# AG-CAT SERVICE NOTES and BULLETINS

**GRUMMAN** AMERICAN AVIATION  
CORPORATION

AG-CAT SERVICE BULLETINS

## SERVICE BULLETIN INDEX

ENGINEERING CHANGE ORDER							CHG. LET.
TITLE:	AILERON - COVER ASSY						
CHG. INC.	EFFECTIVITY	ASAP	PARTS AFFECTED	L	ECO. SERIAL	SIC-528	
BY	CARD POSTED	4-20-60	TOOLS AFFECTED		D.C.R. SERIAL	—	
DATE	CHECKED	ARK 5/19/60	STOCK DISPOSITION		DWG. NO.	A1131 "B"

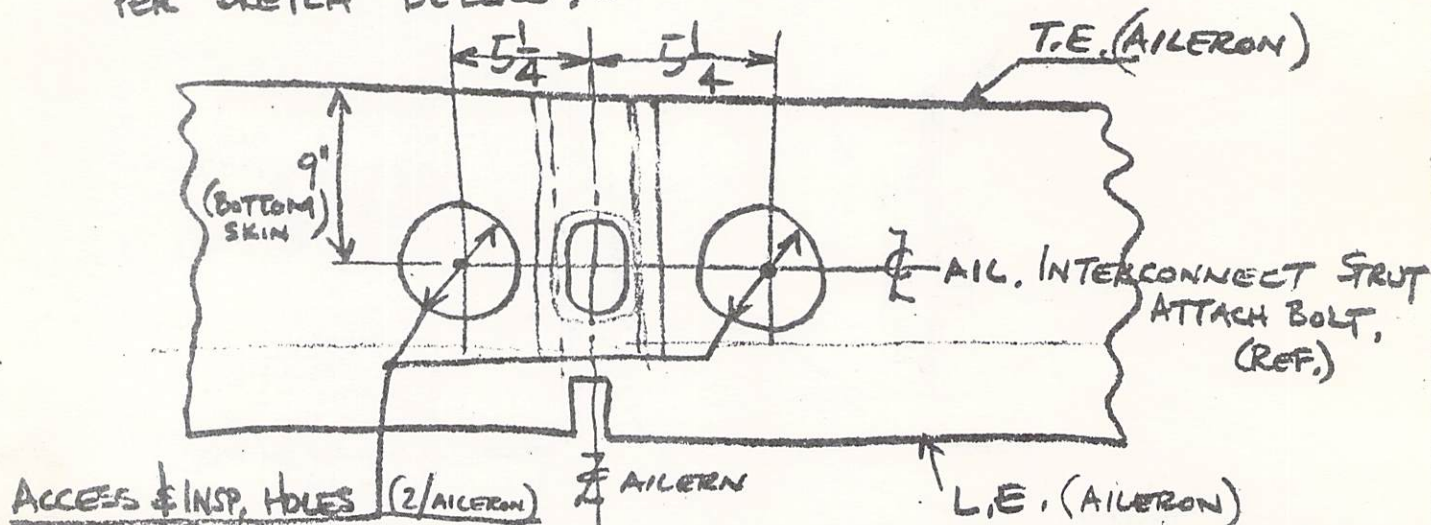
CHANGE: ① ADD TWO EA. of P/N A1004-35 & -33, INSPECTION HOLE METAL INSPECTION COVER PLATES ( $4\frac{5}{8}$ " O.D. SINGLE SPRING TYPE) & COMM'L CELLULOID GROMMETS ( $3\frac{1}{2}$ " I.D. x  $4\frac{5}{8}$ " O.D.) TO THE UNDER SIDE FABRIC COVER ASSY (A1131) PER DETAIL of INSTALL. SHOWN ON DWG A1004 (SECTION J-I) & LOCATED ON AILERON COVER FABRIC ASSY AS PER SKETCH BELOW :-

ENGINEERING CHANGE ORDER						CHG.	
TITLE:	INSTRUMENT MARKINGS G-164					LET.	
CHG. INC.	EFFECTIVITY	ASAP *	PARTS AFFECTED		ECO. SERIAL	5164-540	
BY	CARD POSTED	APK 5-19-60	TOOLS AFFECTED		D.C.R. SERIAL	—	
DATE	CHECKED	PD 5-19-60	STOCK DISPOSITION		DWG. NO.	A1887

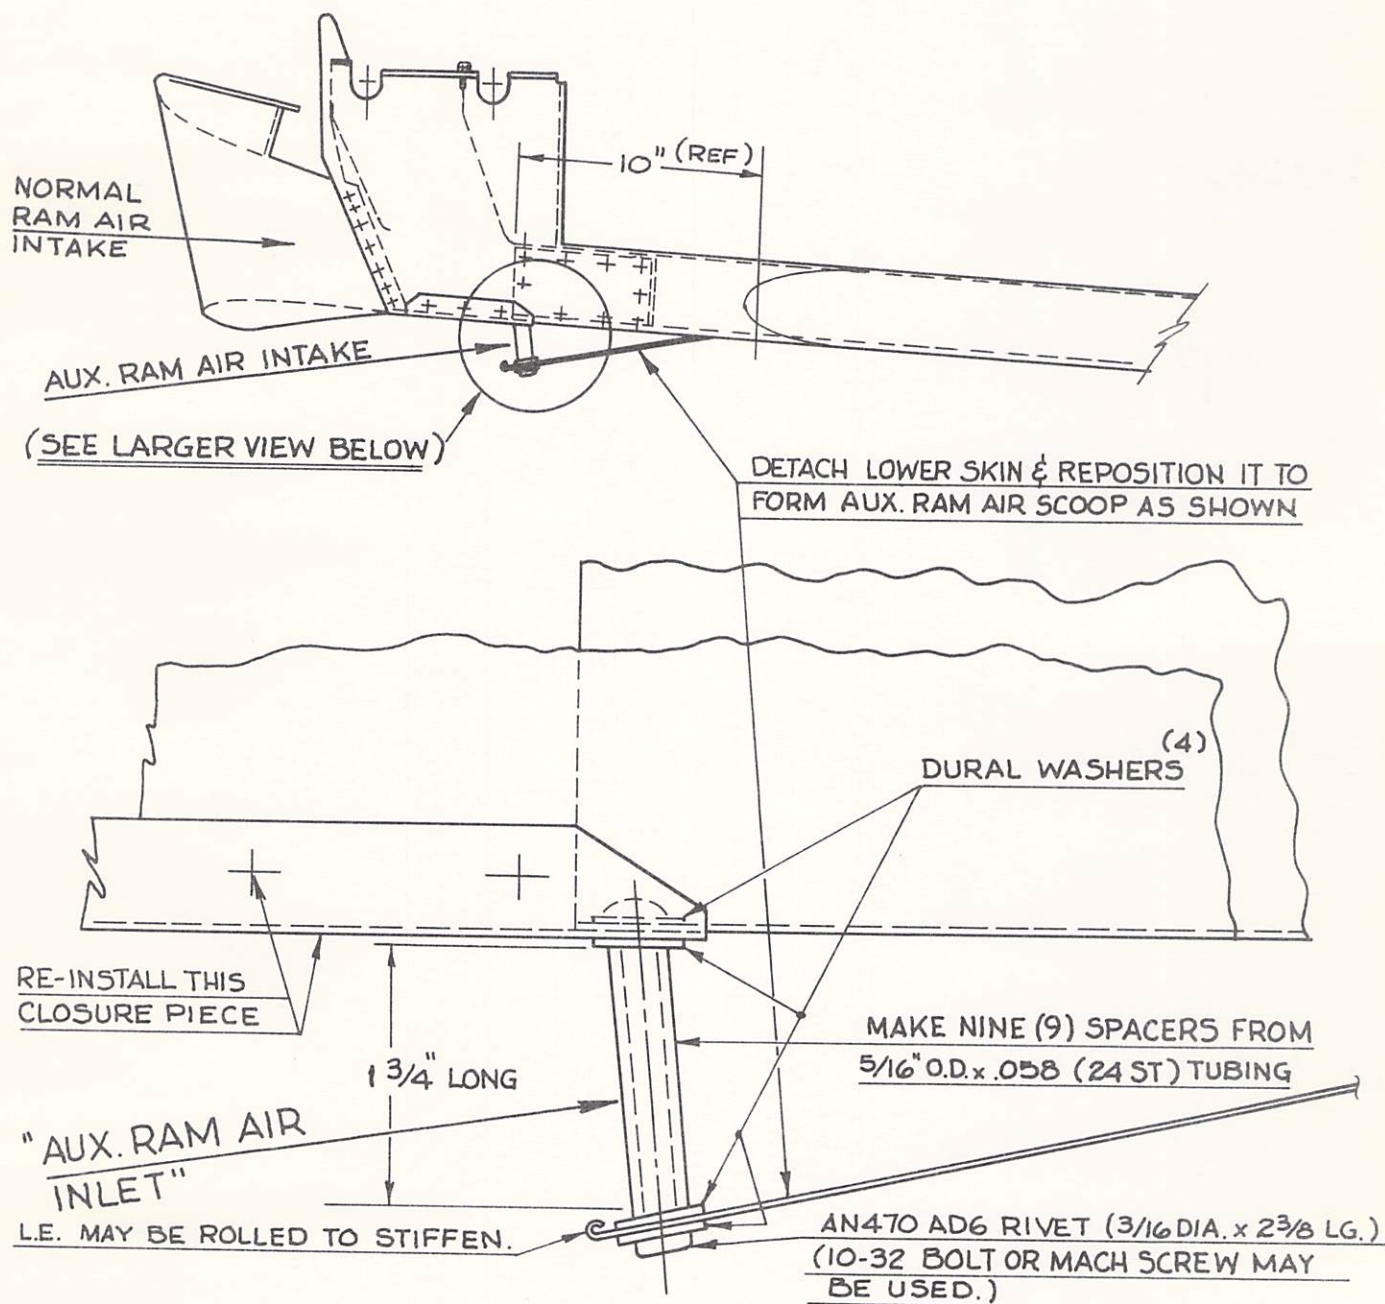
\* THIS CHANGE IS AN FAA INITIATED MANDATORY CHANGE!

## SPREADER MODIFICATION

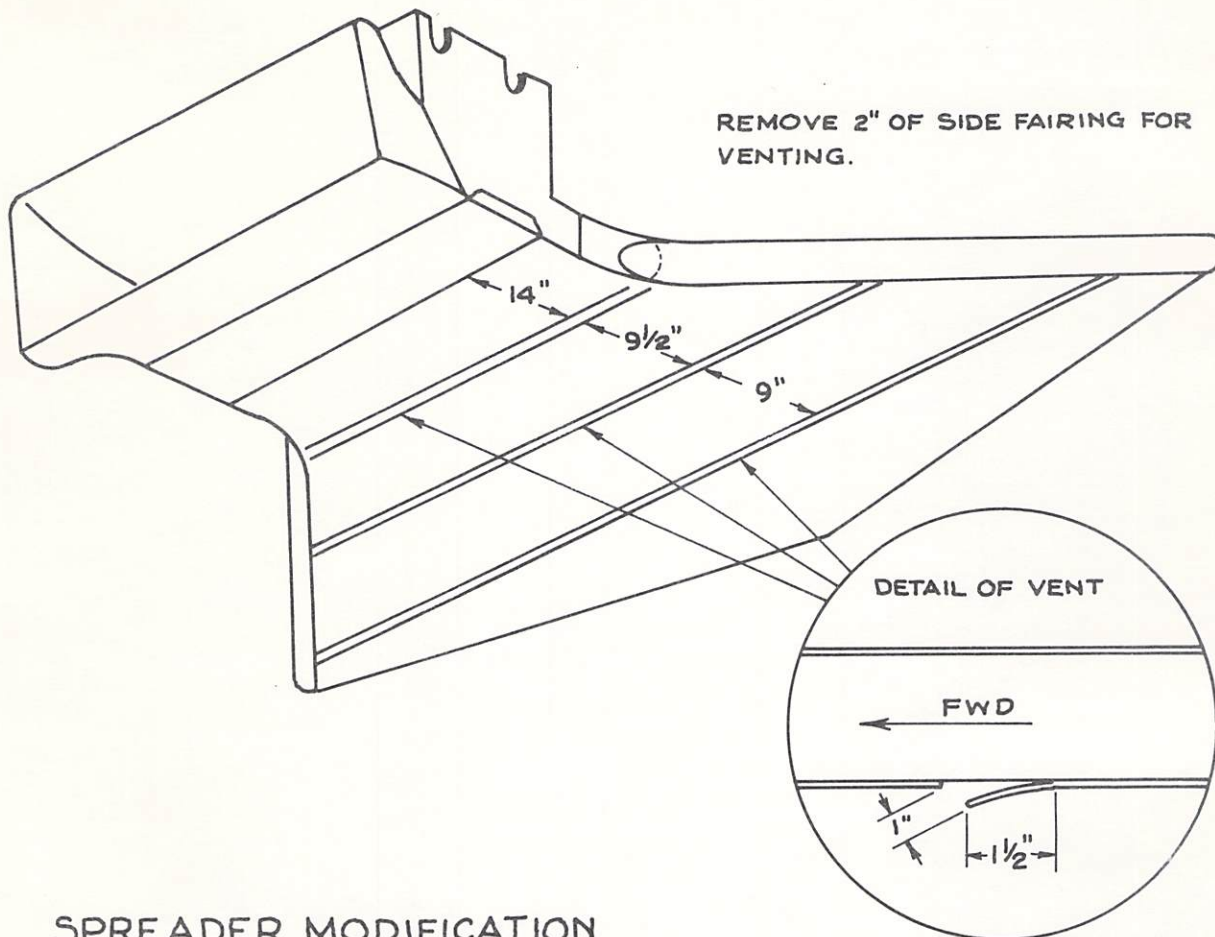
THIS MODIFICATION PRODUCES A MUCH BETTER MIXING OF LIGHT DUSTS AND SHOWS EXCELLENT SHUT OFF CHARACTERISTICS. IT IS HIGHLY RECOMMENDED FOR THOSE OPERATORS ENGAGED IN HEAVY DUSTING OPERATIONS.

ENGINEERING CHANGE ORDER							CHG.	
TITLE:	FAIRING ASSY - FUSELAGE AFT UPPER						LET.	
CHG. INC.	2. R.I.P. 3-15-63	EFFECTIVITY	#36, UP	PARTS AFFECTED	✓	ECO. SERIAL	S164-582	
BY		CARD POSTED	APR 8-25-60	TOOLS AFFECTED	—	D.C.R. SERIAL	—	
DATE		CHECKED	ES-8-25-60	STOCK DISPOSITION	—	DWG. NO.	A1355"A"

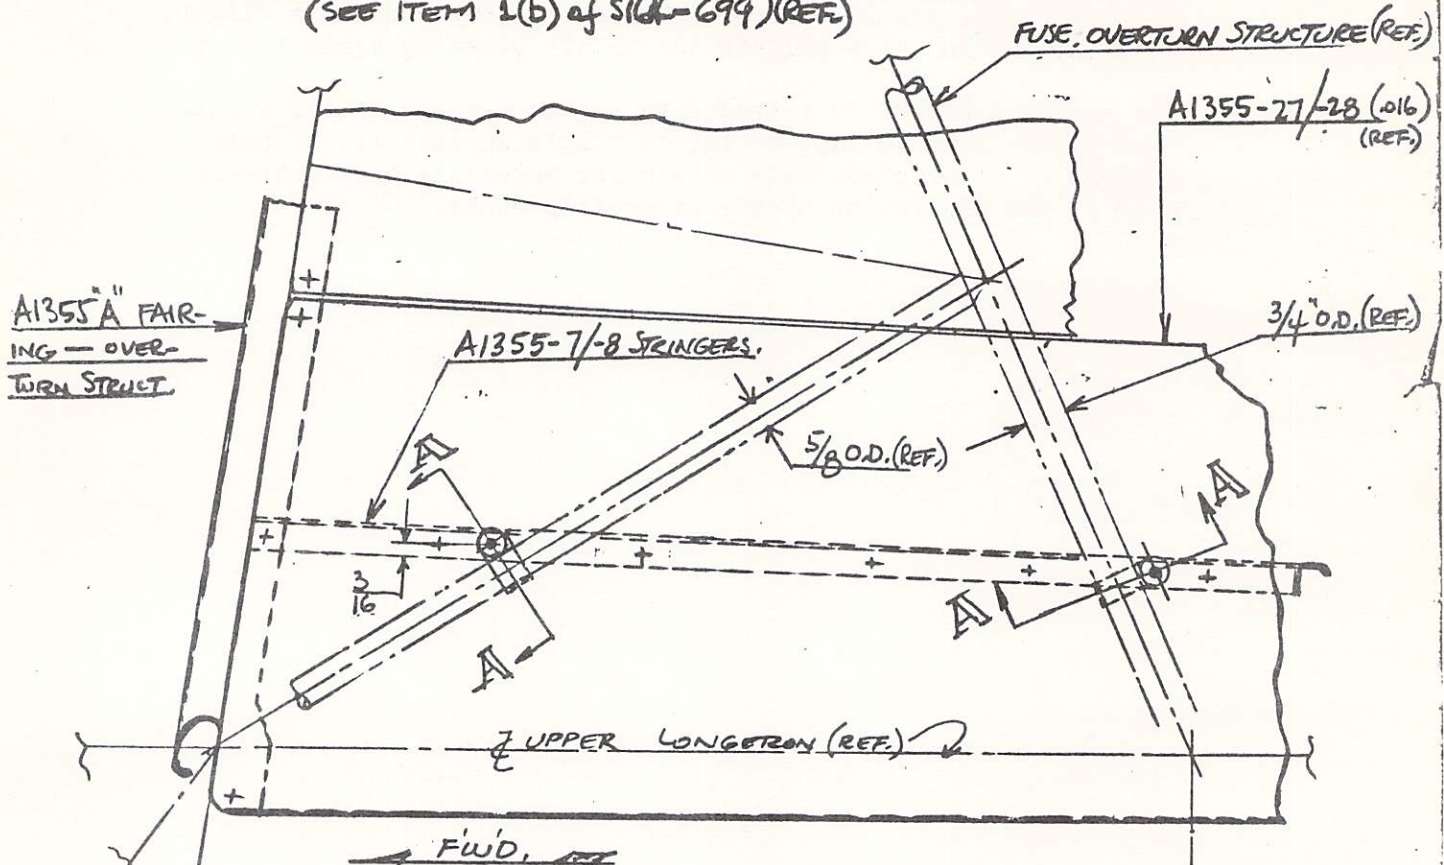
CHANGE: ① ADD CLAMPS & SPACERS AS SHOWN ABOVE TO INSTALL. of A1355"A" OVERTURN STRUCTURE FAIRING.  
(SEE ITEM 1(b) of S164-699)(REF.)

ENGINEERING CHANGE ORDER							CHG. LET.
TITLE:	BLKHD INSTAL. — ENGINE SHROUD						
CHG. INC.		EFFECTIVITY	ASAP	PARTS AFFECTED	✓	ECO. SERIAL	S164-576
BY		CARD POSTED	APV 8-18-60	TOOLS AFFECTED	—	D.C.R. SERIAL	—
DATE		CHECKED	ES 8/18/60	STOCK DISPOSITION	SCRAP	DWG. NO.	A1627

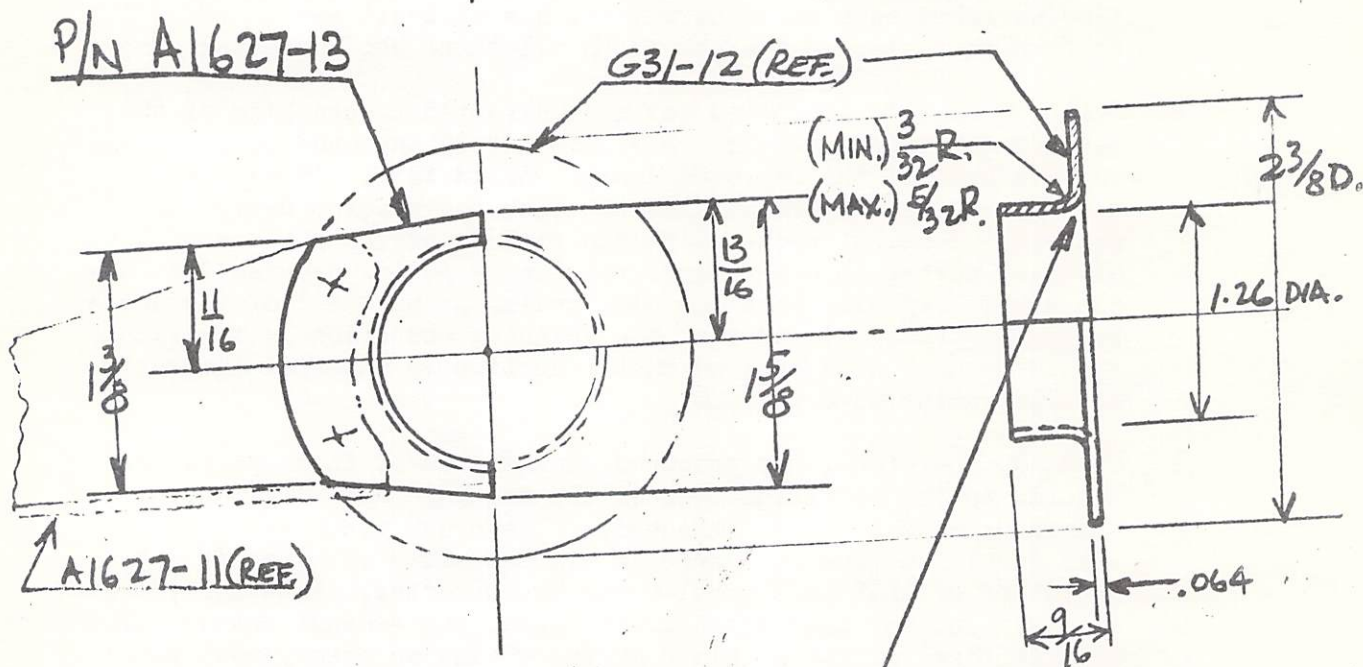
Change detail shape of P/N A1627-13 TO DETAIL SHOWN BELOW. USE EITHER  $.063$  2024-O SH'T (H.T. TO T4 AFTER SPINNING) OR  $.064$  5250 SH'T. (5250 SH'T PREFERRED)

ENGINEERING CHANGE ORDER							CHG. LET.
TITLE:	STRUCTURE (ASSY) — FUSELAGE						B
CHG. INC.	2-19-63	EFFECTIVITY	SEE NOTE 2	PARTS AFFECTED	—	ECO. SERIAL	5164-623
BY		CARD POSTED	ARK 12-21-60	TOOLS AFFECTED	—	D.C.R. SERIAL	—
DATE		CHECKED	ES 12-21-60	STOCK DISPOSITION	—	DWG. NO.	A1300 "A"

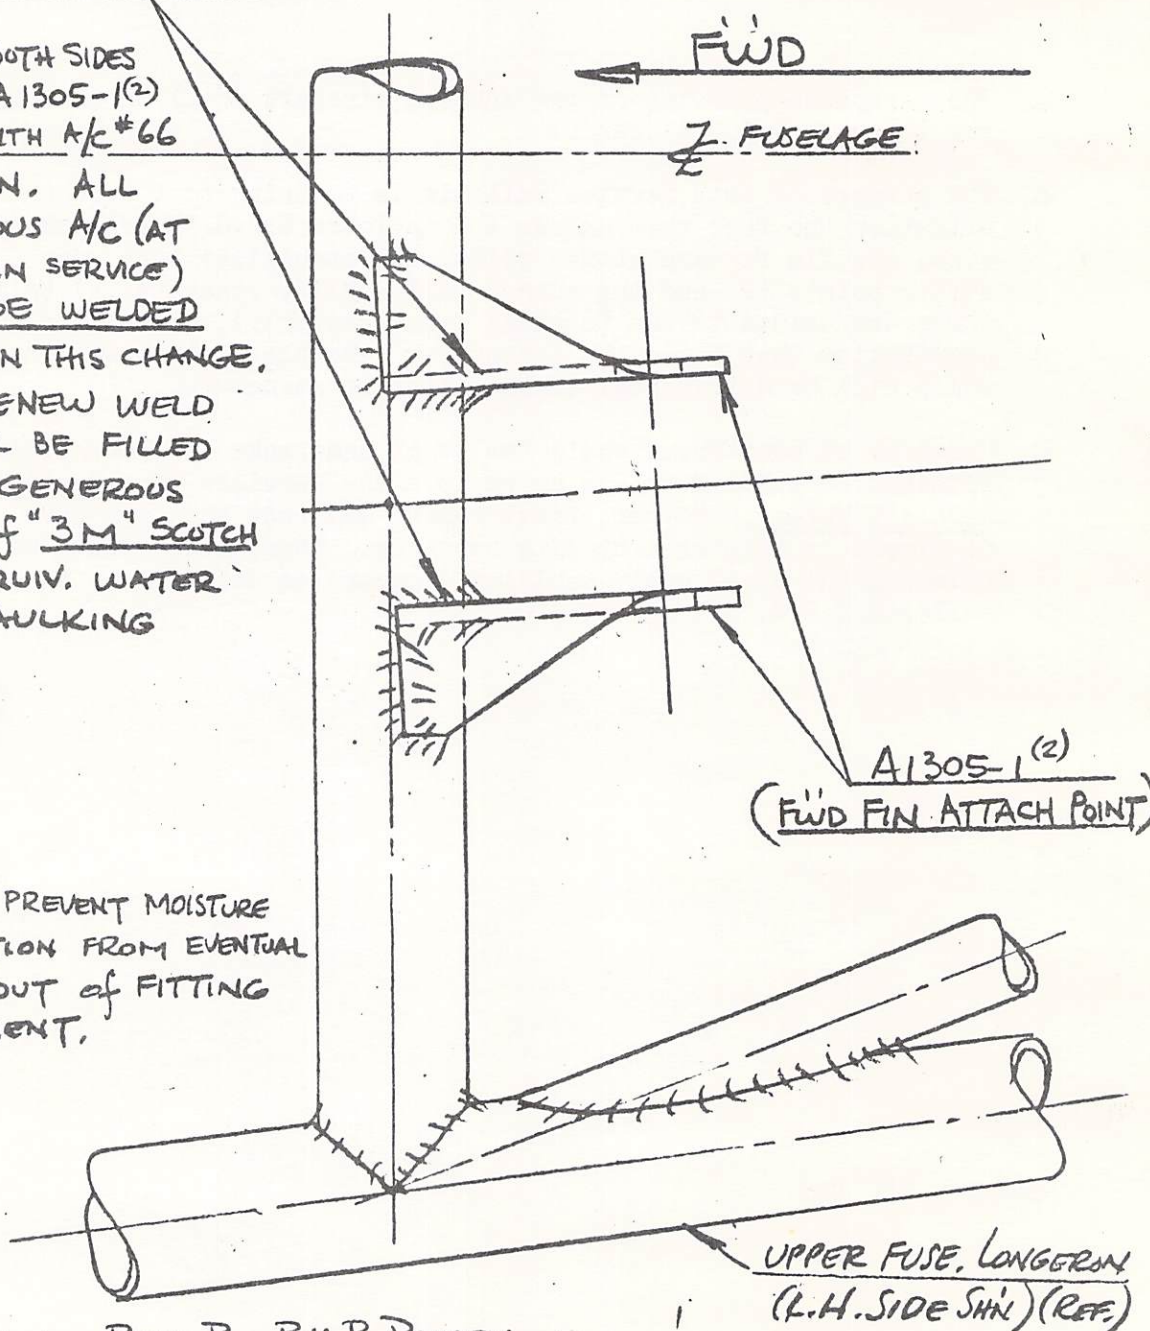
CHANGE: ① CHANGE "WELD OUTSIDE ONLY AS SHOWN" NOTE ON SECTION "H-H" TO "WELD BOTH SIDES AS SHOWN". (SEE CHANGE IN SECTION "H-H" BELOW)

② WELDING OF BOTH SIDES OF FITTINGS A1305-1(2) WILL START WITH A/C #66 IN PRODUCTION. ALL OTHER PREVIOUS A/C (AT FACTORY OR IN SERVICE) SHALL NOT BE WELDED AS SHOWN IN THIS CHANGE. HOWEVER, THESE NEW WELD AREAS SHALL BE FILLED IN WITH A GENEROUS QUANTITY OF "3M" SCOTCH CAULK OR EQUIV. WATER RESISTANT CAULKING COMPOUND.

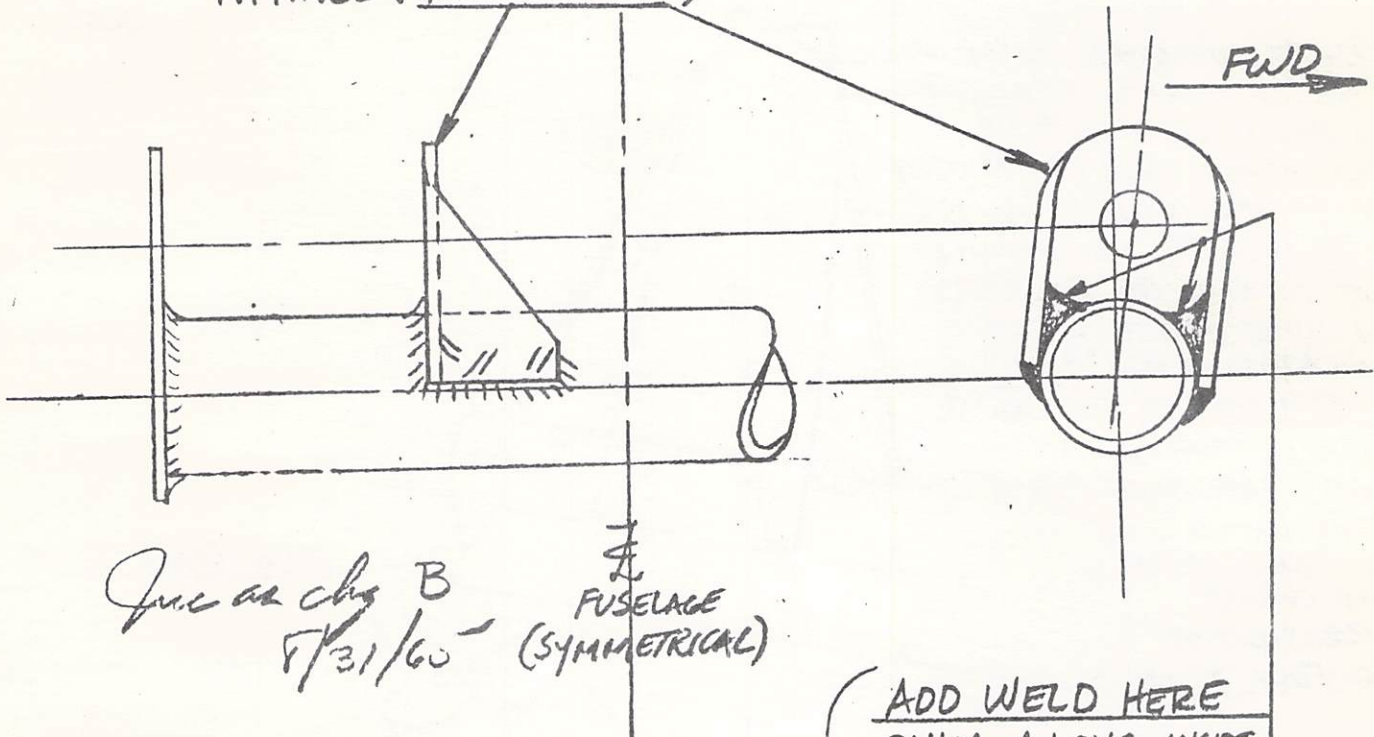
CHANGE: ① ADD WELD TO INSIDE OF STABILIZER REAR SPAR FUSELAGE FITTINGS <sup>(2)</sup>(P/N A1306-11) AS SHOWN BELOW.

② THIS ADDED WELD SHALL START WITH A/C #66 IN PRODUCTION. ALL OTHER PREVIOUS A/C (AT FACTORY OR IN SERVICE) SHALL NOT BE WELDED IN THESE AREAS FOR FEAR OF CRACK DEVELOPMENT. THEY SHALL BE FILLED IN WITH A GENEROUS FILLET OF "3M" SCOTCH CAULK (OR EQUIV.) WATER RESISTANT CAULKING COMPOUND.

ADD WELD HERE ONLY ALONG INSIDE OF EACH LATERAL LEG OF FITTINGS #A1306-11 <sup>(2)</sup> AS SHN. DO NOT WELD ON FACE OF FITTING WHERE IT WILL INTERFERE WITH BOLT.

ENGINEERING CHANGE ORDER						CHG.	
TITLE:	BRACKETS (INSTALL.) - SURFACE CONTROLS					LET.	
CHG. INC.		EFFECTIVITY	SEE NOTE 2	PARTS AFFECTED	—	ECO. SERIAL	5164-625
BY		CARD POSTED	KPK 12-21-60	TOOLS AFFECTED	—	D.C.R. SERIAL	—
DATE		CHECKED	ES 12-21-60	STOCK DISPOSITION	—	DWG. NO.	A1833

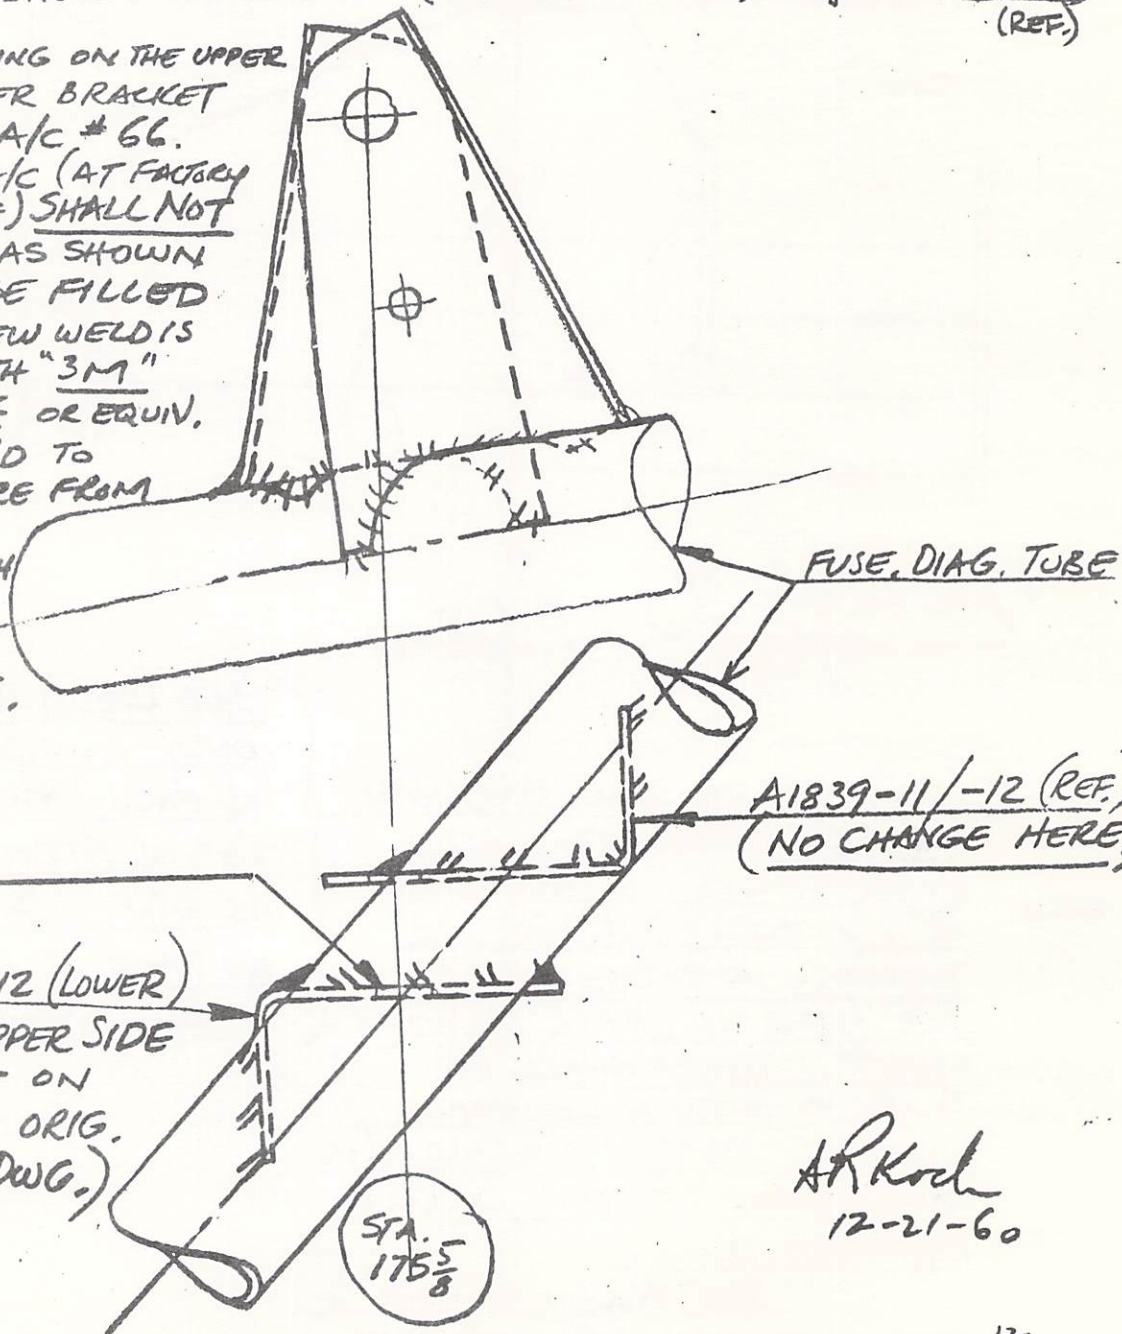
CHANGE: ① CHANGE LOCATION OF WELD (L.H. & R.H. INSTALLATIONS) OF RUDDER CABLE PULLEY BRACKET AT FUSE, STA. 175 $\frac{5}{8}$  AS SHOWN BELOW :- (AFFECTS VIEW "D-D" OF DWG. A1833) (REF.)

ENGINEERING CHANGE ORDER							CHG.
TITLE:	WING OUTER PANEL - STRUCTURAL ASSY						LET.
CHG. INC.	EFFECTIVITY	ALL A/C	PARTS AFFECTED	✓	ECO. SERIAL	5164-684" B	
BY	CARD POSTED	ARK 9-29-61	TOOLS AFFECTED	✓	D.C.R. SERIAL	—	
DATE	CHECKED	ES 9-29-61	STOCK DISPOSITION	REWORK	DWG. NO.	A1003

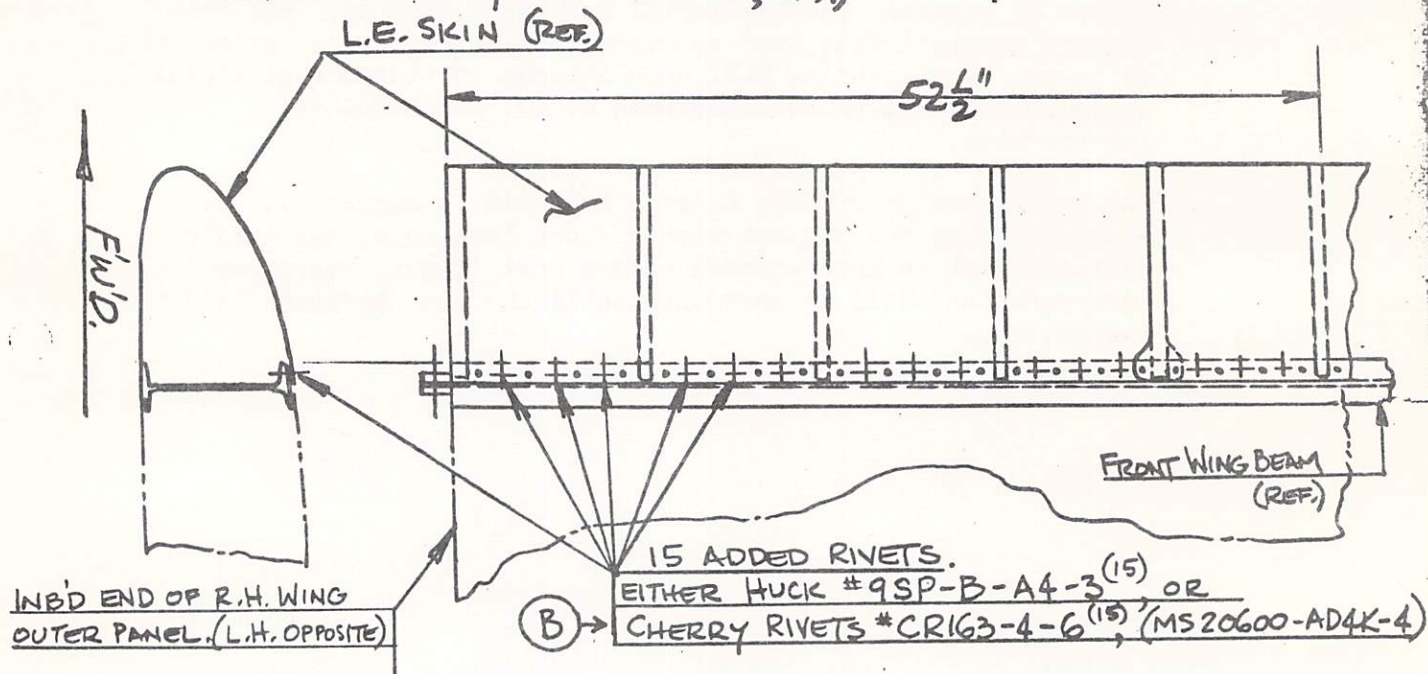
CHANGE: 1. ADD 15 HUCK RIVETS (#9SP-B-A4-3) OR 15 <sup>(B)</sup> CHERRY RIVETS (#CR163-4-6 OR #MS 20600-AD4K-4) AS SHOWN BELOW TO EACH OF FOUR (4) WING OUTER PANELS FOR ATTACHING L.E. SKINS TO THE FORWARD WING BEAM UPPER CAPSTRIPS. THESE ADDED BLIND RIVETS ARE TO BE LOCATED MIDWAY BETWEEN EXISTING RIVETS (AS SHOWN ON SKETCH BELOW BY THE SYMBOL, (+).)

REASON: 1. THESE ADDED RIVETS ARE REQ'D IN THE REGION OF THE PROP. SLIP-STREAM TO STRENGTHEN THE L.E. SKIN ATTACHMENT AGAINST PROP BLAST ACTION. THIS IS A MANDATORY CHANGE!
